A meeting of the **WAVERLEY LOCAL PLANNING PANEL** will be held on Level 3, Waverley Council Chambers, Cnr Bondi Road and Paul Street, Bondi Junction at:

WLPP-1906.1 PAGE 5 5 & 5A Thomas Street, Bronte - Demolition of a pair of semi-detached dwellings and construction of two semi-detached dwellings, including shared pool and common garage (DA-342/2018)

Report dated 13 June 2019 from the Development and Building Unit.

Recommendation: That the application be refused in accordance with the reasons contained in the report.

9,600mm MAX HT AT NO. 5
ABOVE EXISTING GROUND

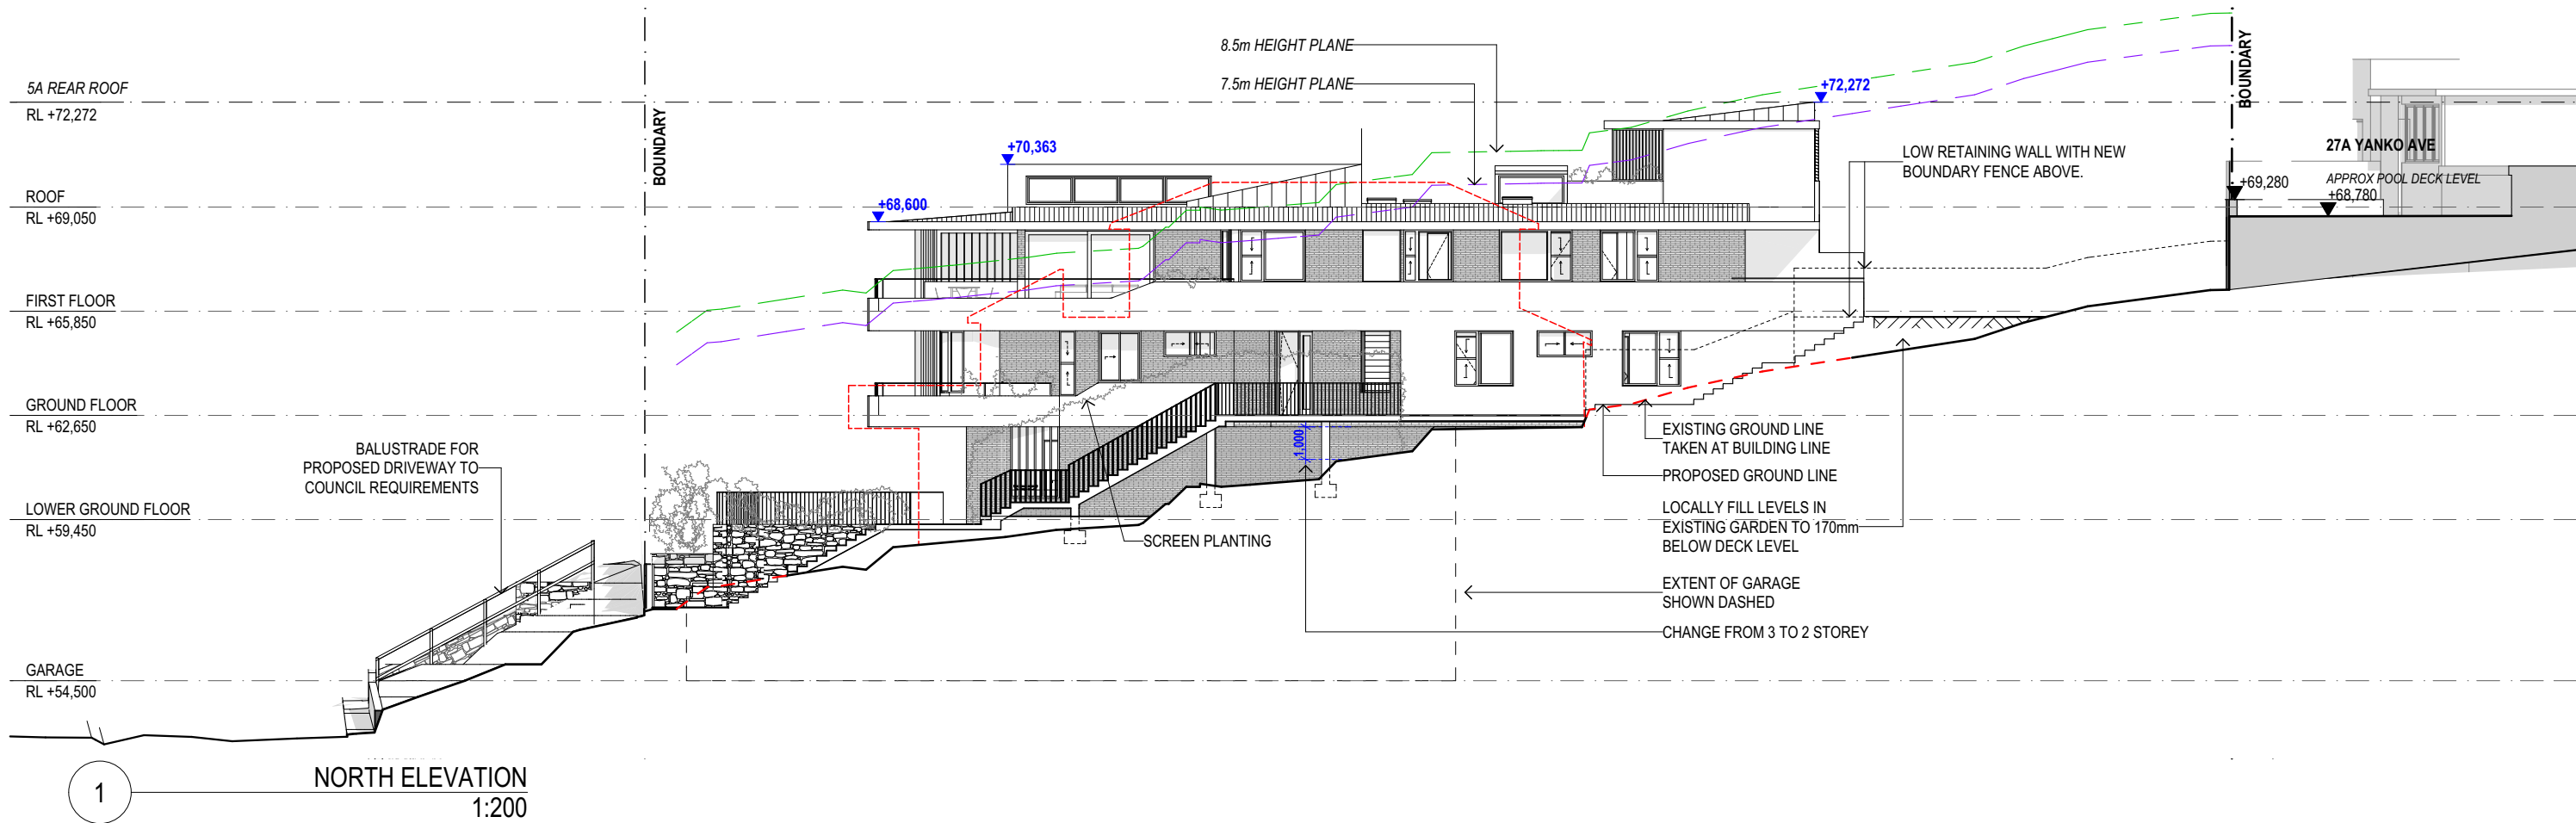
The site is subject to a maximum building height control of 8.5m. The proposed development has a building height of 9.6m (for No. 5) and 10.54m (for No. 5A) exceeding the standard by 1.1m or 12.9% and 2.04m or 24% respectively. Refer *Figure 4* and *Figure 6* for a diagrammatic representation of the variation.

DRAWING TITLE
**5 ST THOMAS STREET - NORTH
SECTION - 1:100**
DRAWING STATUS
DA SUBMISSION

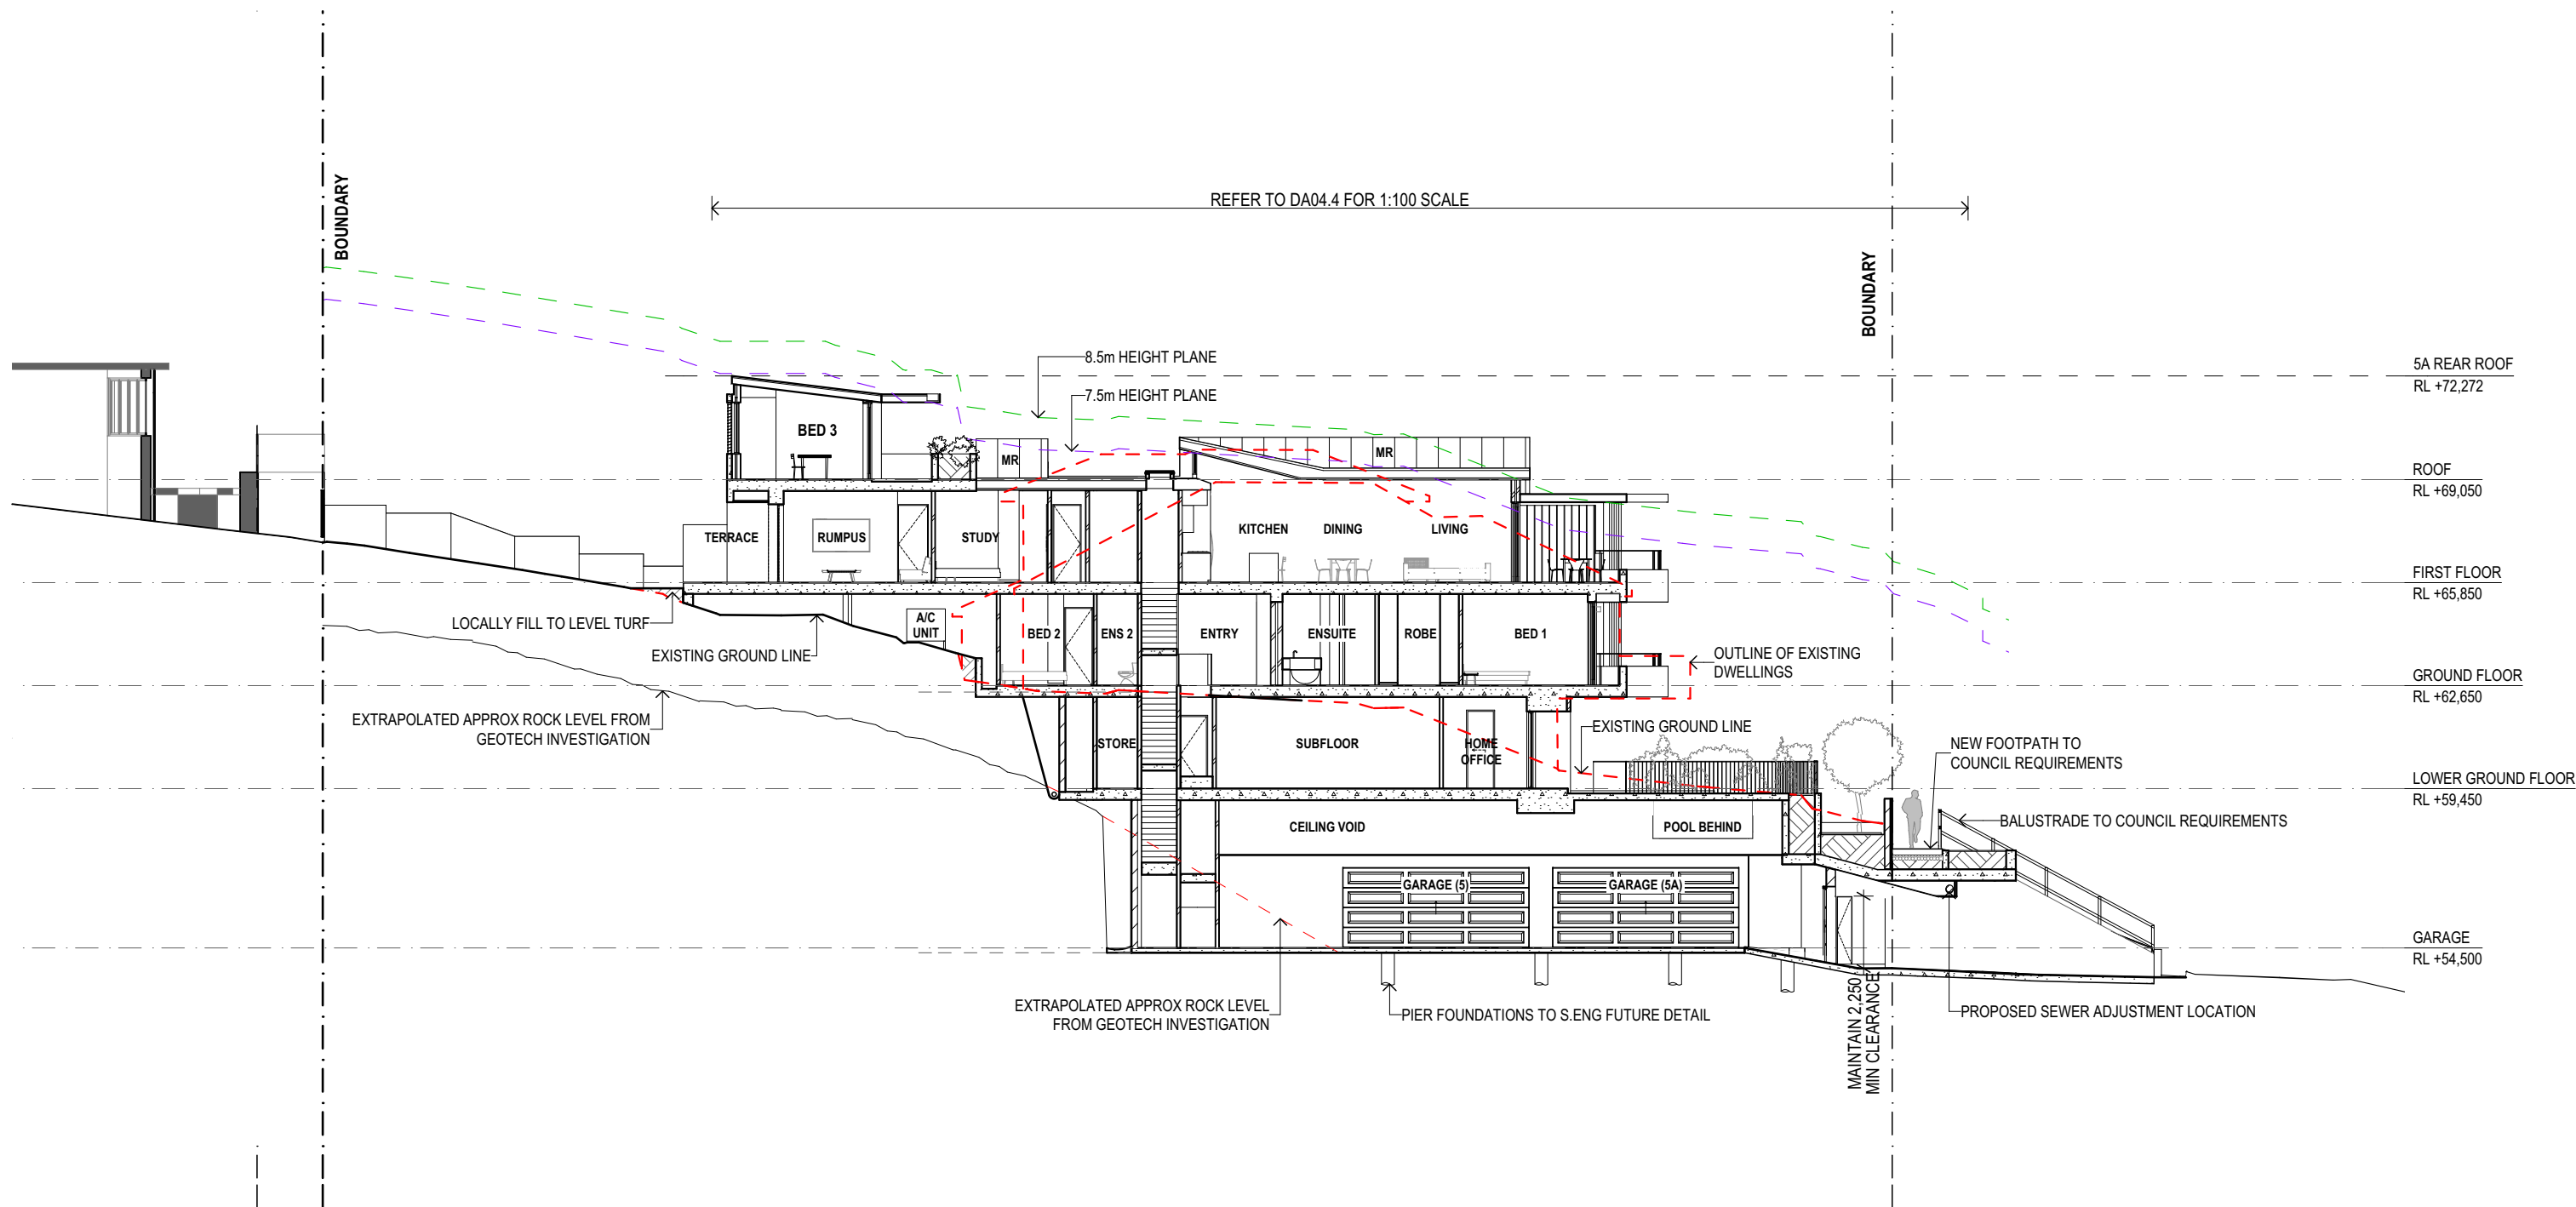
The area marked as 'subfloor' (within the proposed dwelling at No. 5) is capable of being used as a habitable space. As shown on the North Section plan (DA04.2), this space will have a finished floor and a ceiling height which complies with the minimum height of a habitable space (Refer *Figure 4*). Despite having a very small opening at the northern elevation (refer Lower Ground Floor - DA02.2), for all intents and purposes this subfloor space can be used as a habitable space, thus is counted as GFA. Accordingly the calculated FSR for No. 5 St Thomas Street is approximately 0.78:1, which equates to a 31.8m² or a 12% variation.

Figure 4: Extract of submitted architectural plans (5 St Thomas Street North Section – DA04.2). The area shaded yellow represents the height of building non-compliance. The area outlined in red shows that the ‘subfloor’ should be counted as GFA.
